ADDENDUM NO. 1

August 24, 2022

Modify Atrium Lighting & Sprinklers – Mann Library - REBID
Addendum No, 1
August 24, 2022
Page 2

100% CONSTRUCTION DOCUMENTS
SUCF 161039 - Modify Atrium
Lighting & Sprinklers-Mann Library
 237 Mann Drive, Ithaca, NY 14853

A151R1

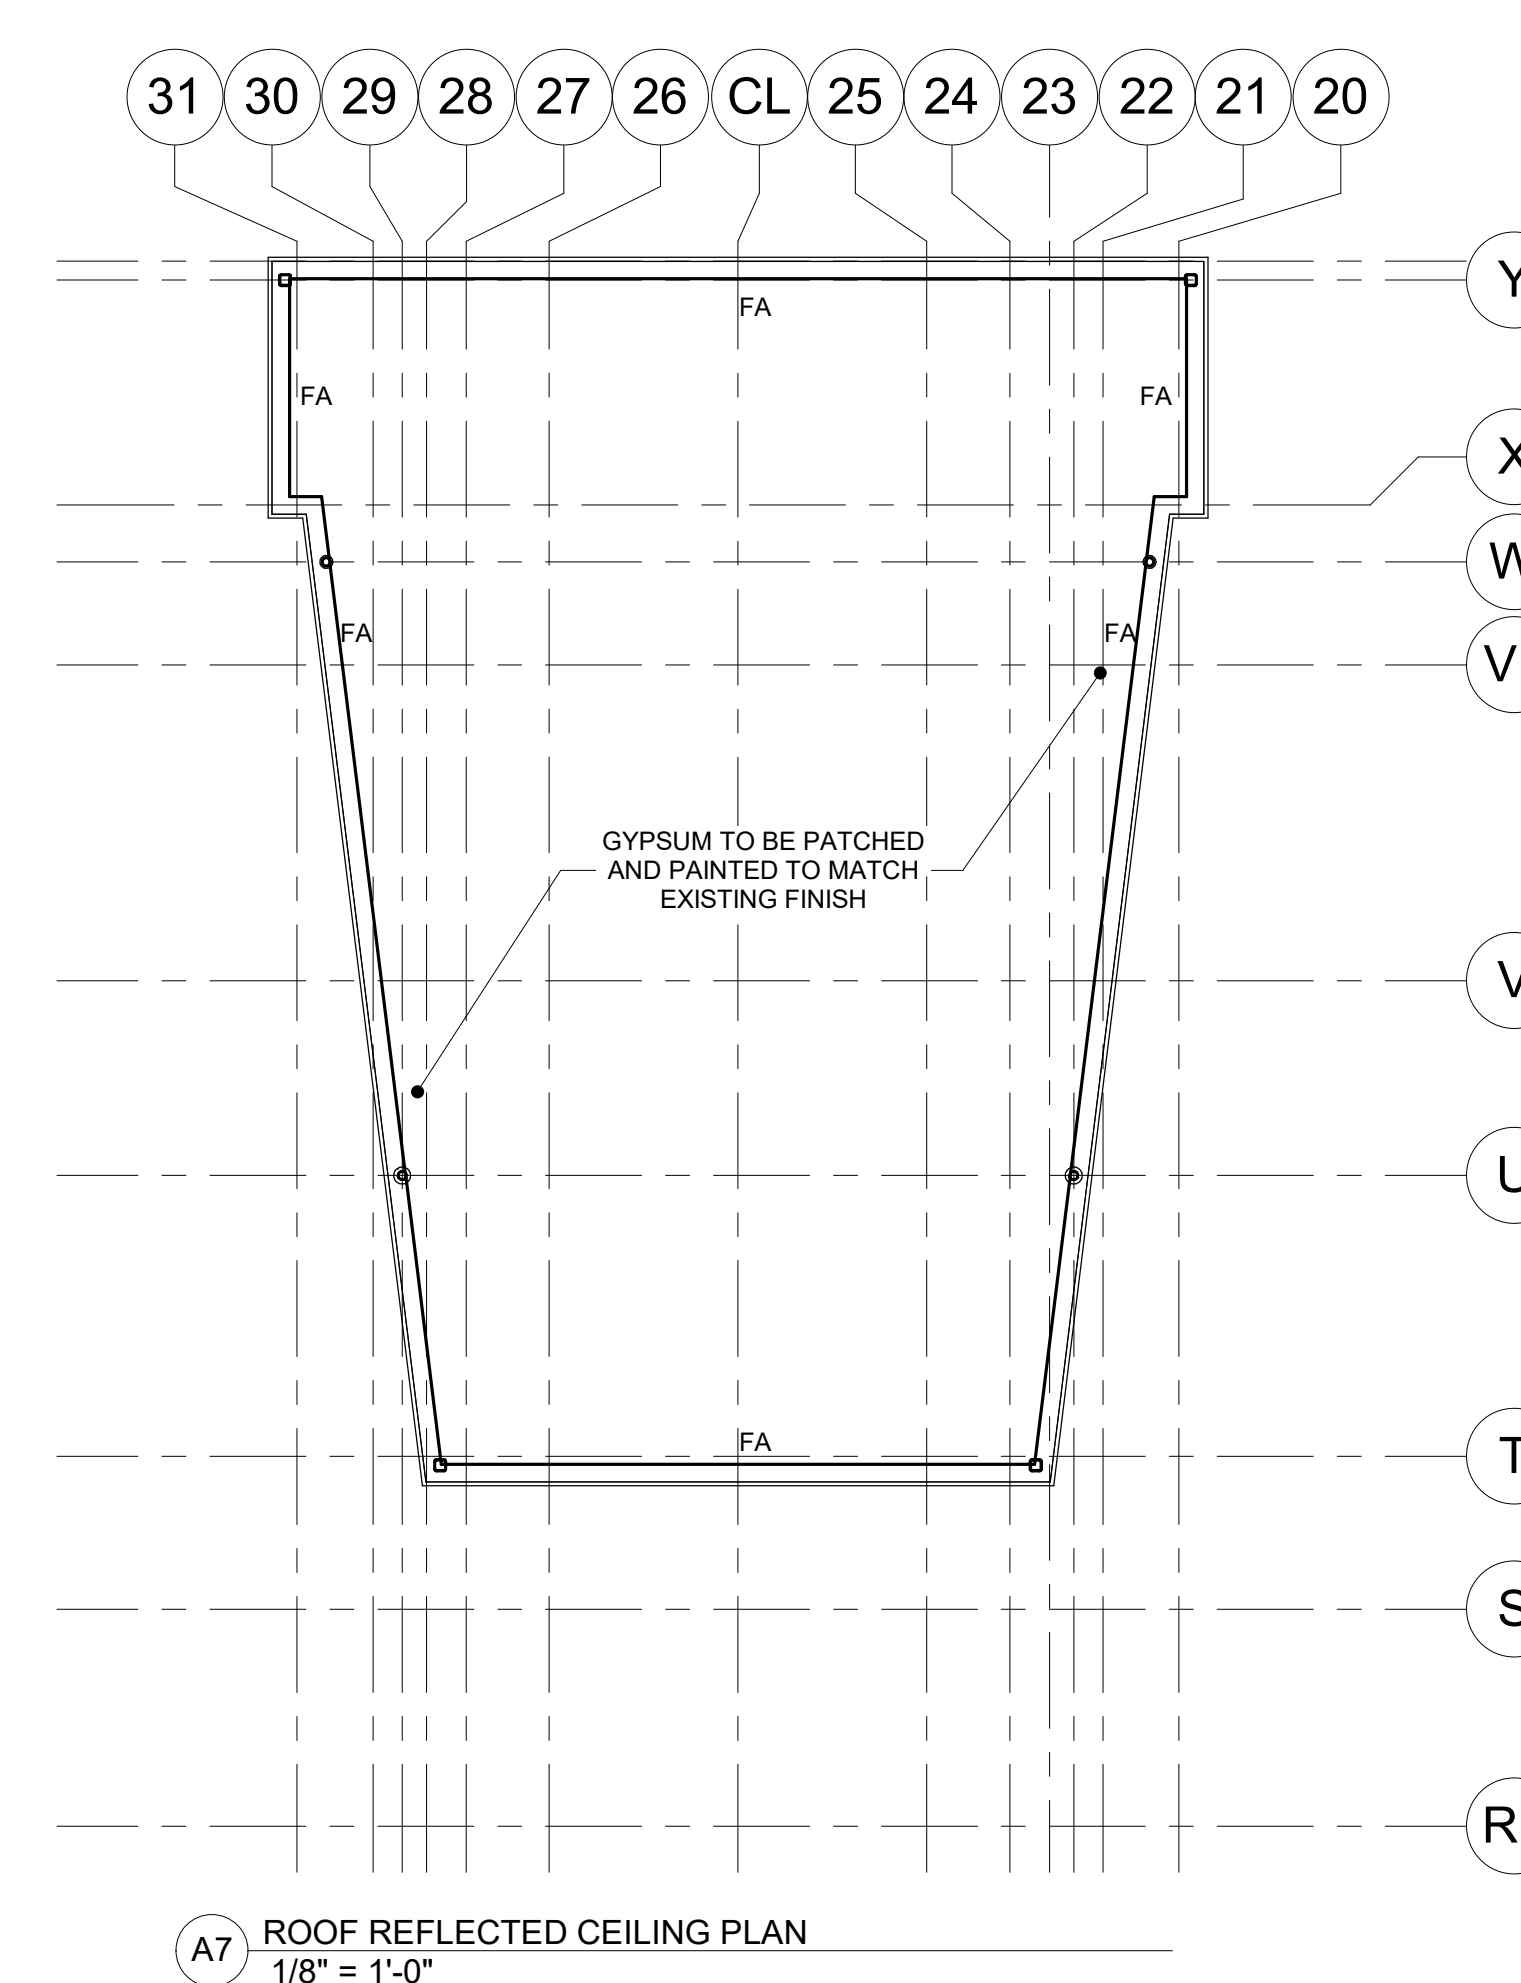
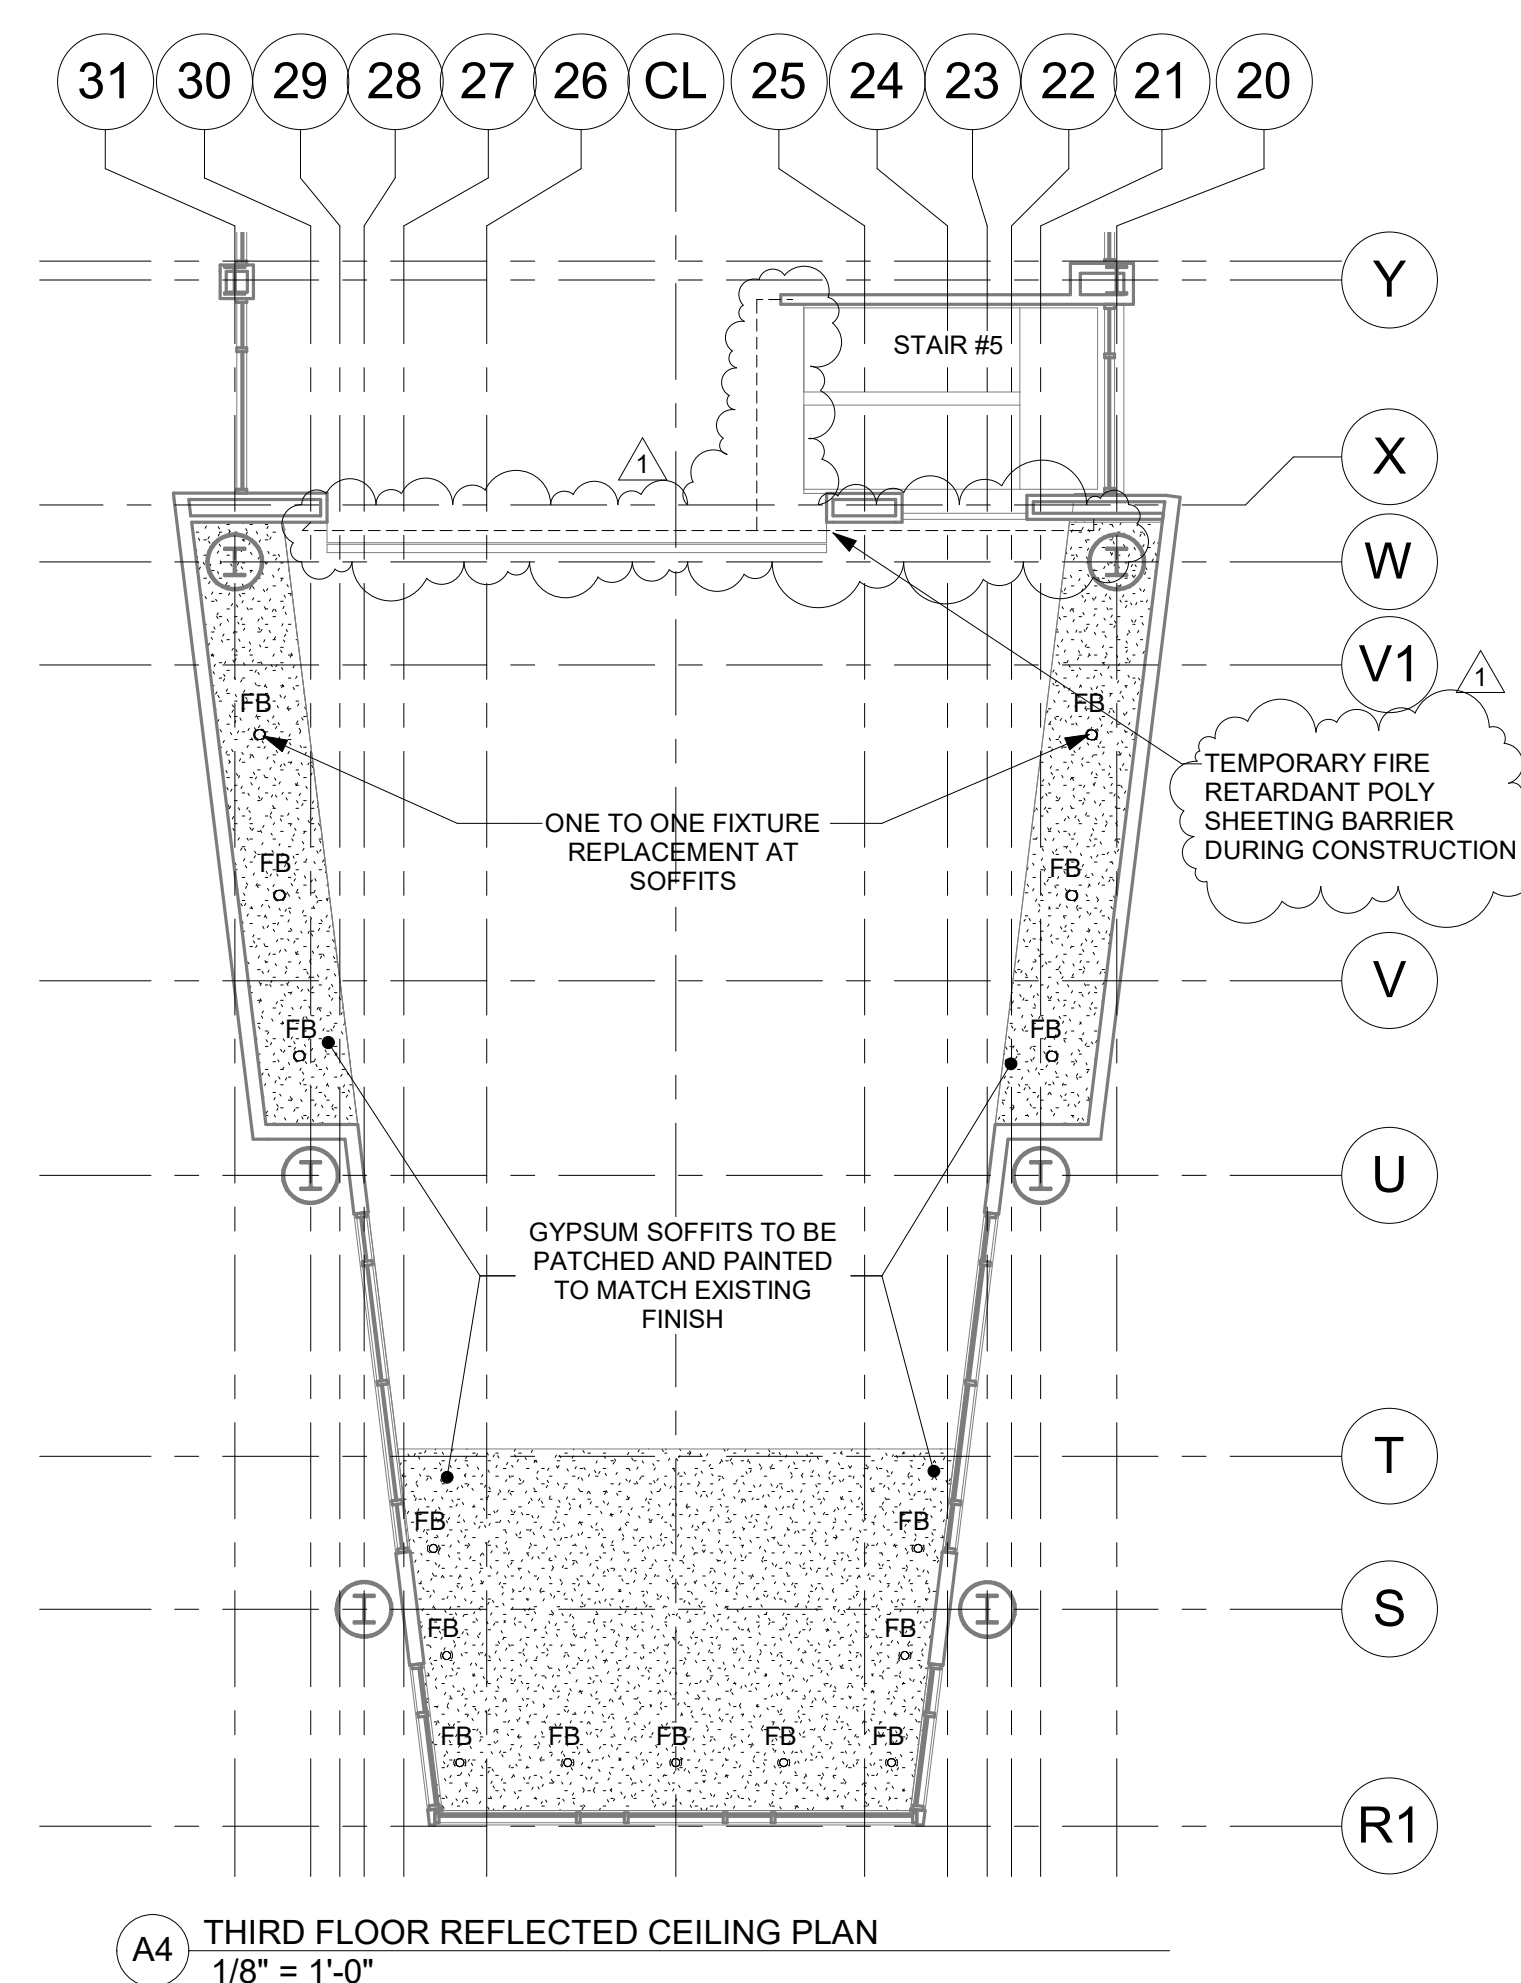
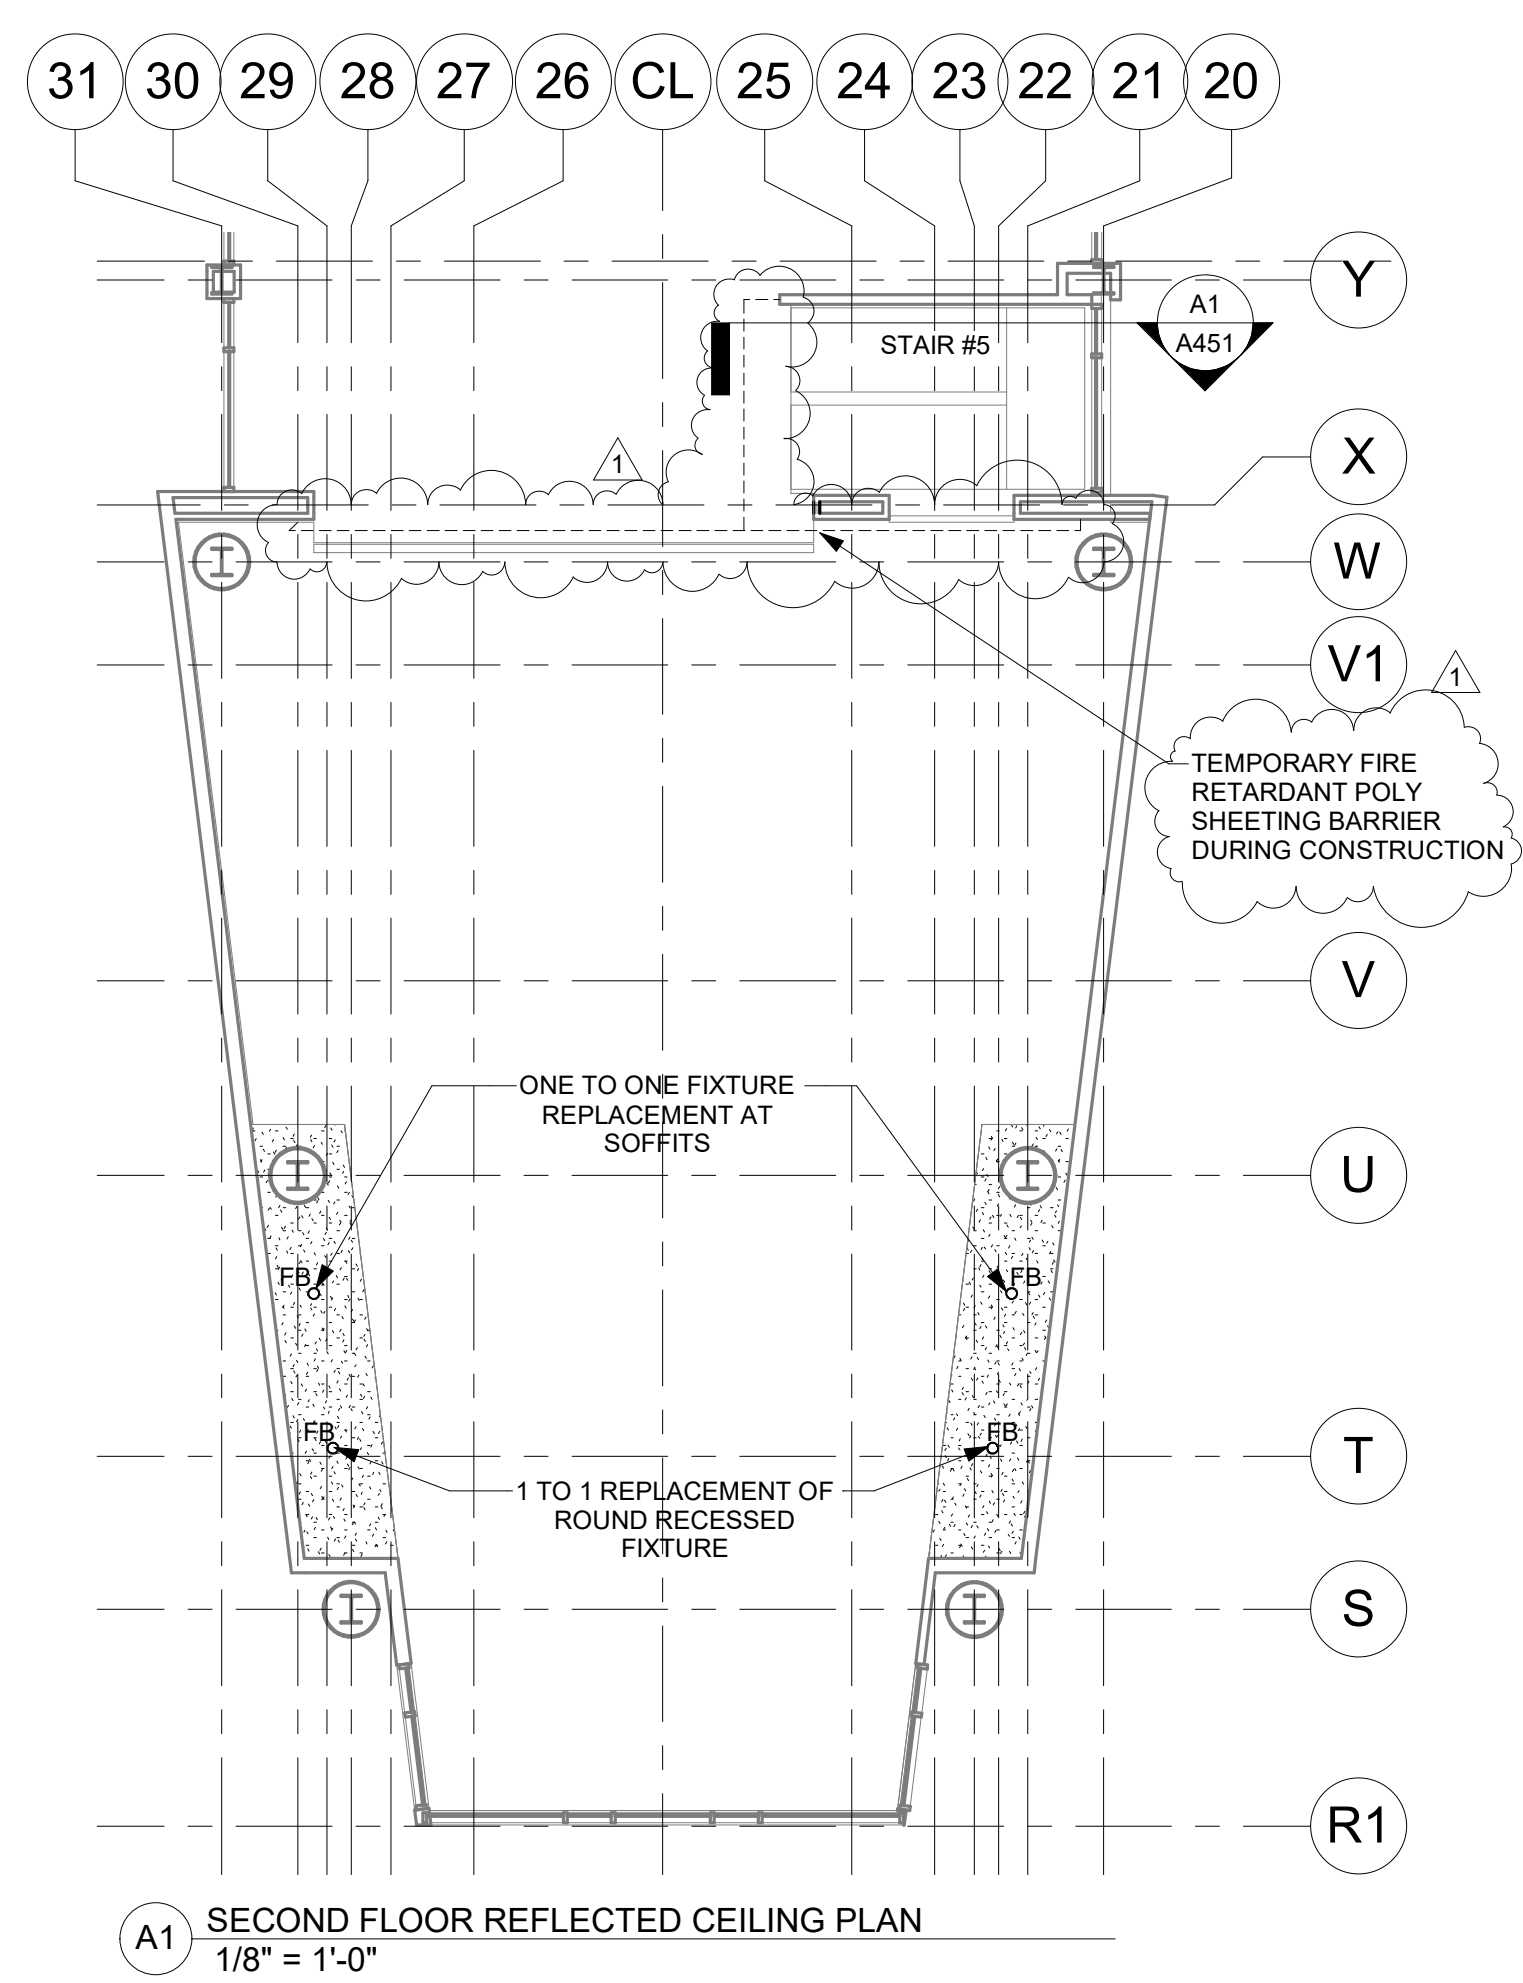
RFI/ Response Index	Page/ Dwg./Spec./Rep. Number	Section/ Paragraph/Topic	RFI	Design Team Response
1	Specifications		Fixture schedule or approved fixture descriptive in the specifications section is missing.	See Addendum No. 1, Item 2. The fixture schedule can be found in Drawing A151R1. Fixture description and specification can be found in Specification 26 51 00 ARCHITECTURAL LIGHTING FIXTURES.
2			Can poly plastic sheeting be used instead of studs and plywood for the temporary barrier? Clarify where a barrier is needed.	See Addendum No. 1, Items 1 and 2. The install of temporary fire retardant poly barrier during construction to limit access and prevent dust from spreading is allowed. The barrier is to be installed around the perimeter of the atrium on Level 01 and around any openings within the atrium in order to prevent dust from spreading. See drawing A101R1 and A151R1.
3	Specifications		Is there a requirement for fire watch during construction?	Fire watch requirements can be found in the specifications Section 01 50 00 TEMPORARY FACILITIES AND CONTROLS.
